**YUCCA MOUNTAIN
SITE CHARACTERIZATION
PROJECT.**

**Report of
the Peer Review Panel
on the Early
Site Suitability Evaluation
of the Potential Repository Site at
Yucca Mountain, Nevada**

January 1992

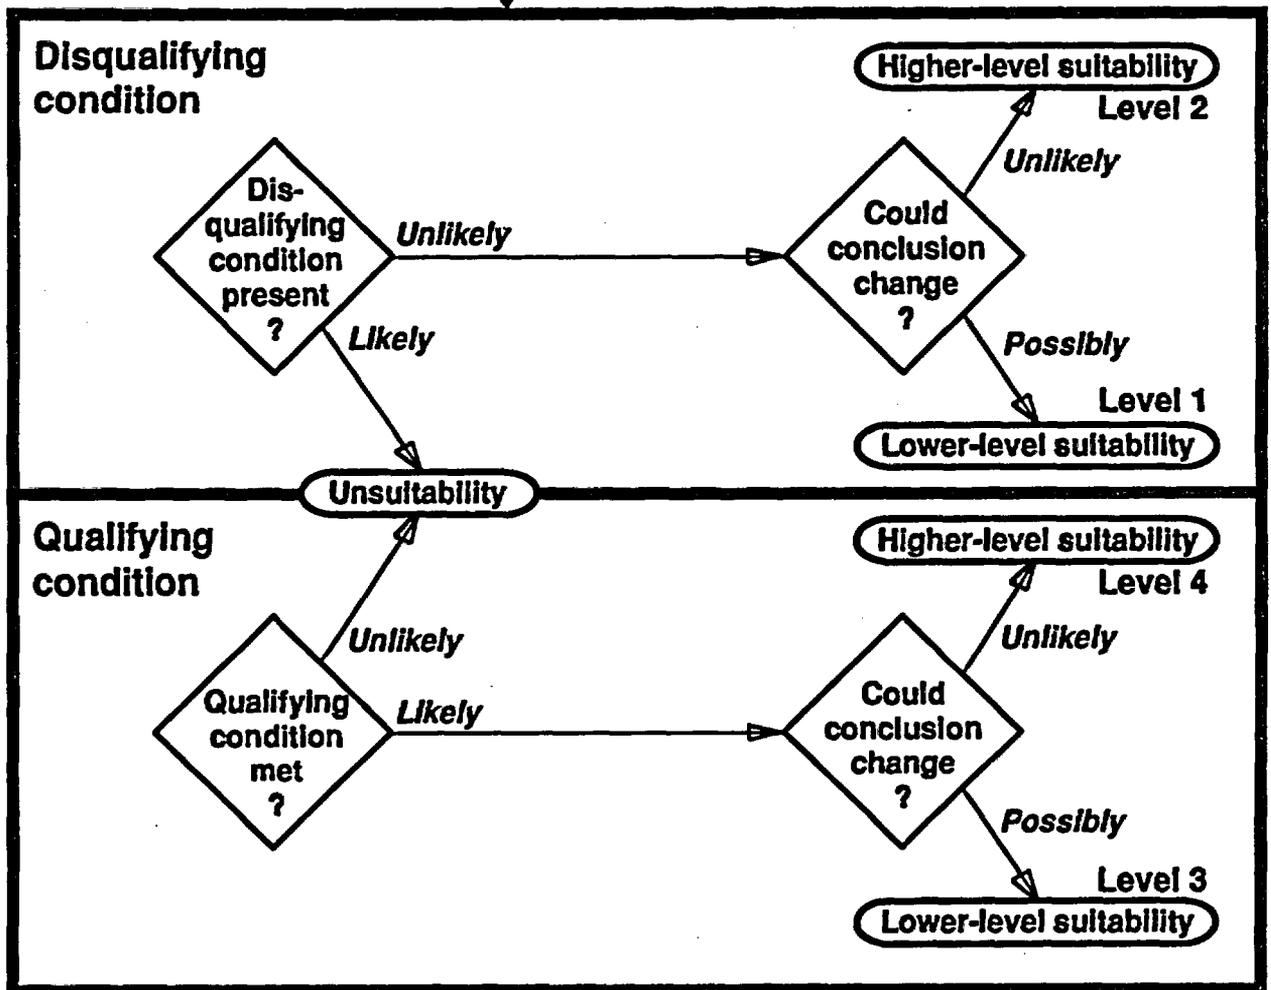
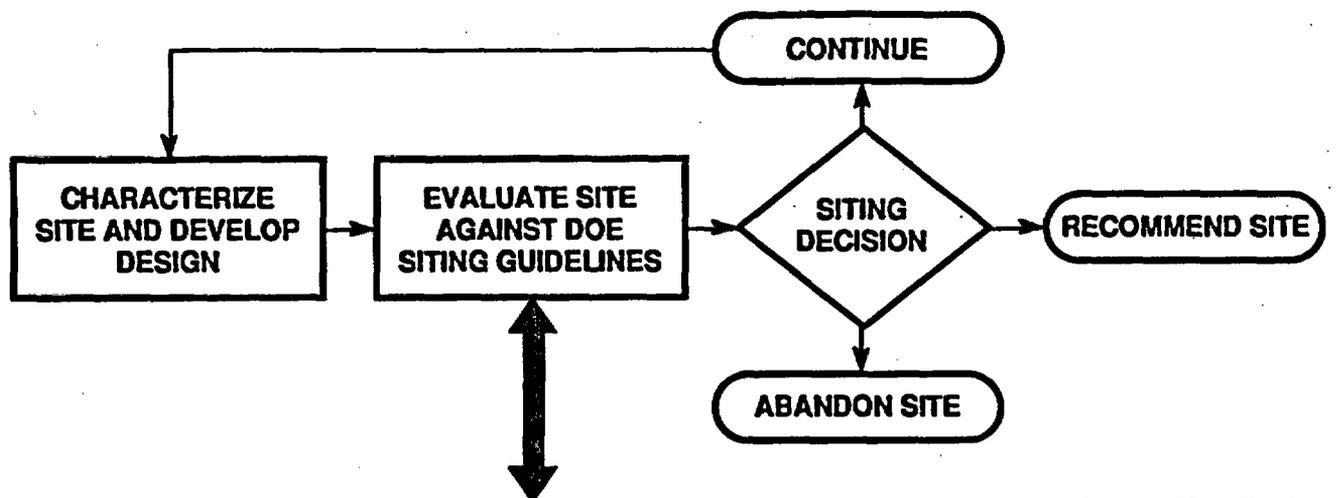
| 4. Organization <u>Brigham Young University</u> | 8. Paragraph <u>Figure 1-2</u> |

On the disqualifying condition portion where you ask if the conclusion could change, I would substitute "possibly" for "likely." You really don't believe the conclusion will change but, because it possibly could, additional data are called for.

The reviewer makes a good point, which was also made in Dr. Hodges' Comment #2. The figure and its caption will be changed as shown on the attached figure (will be Figure 1-3).
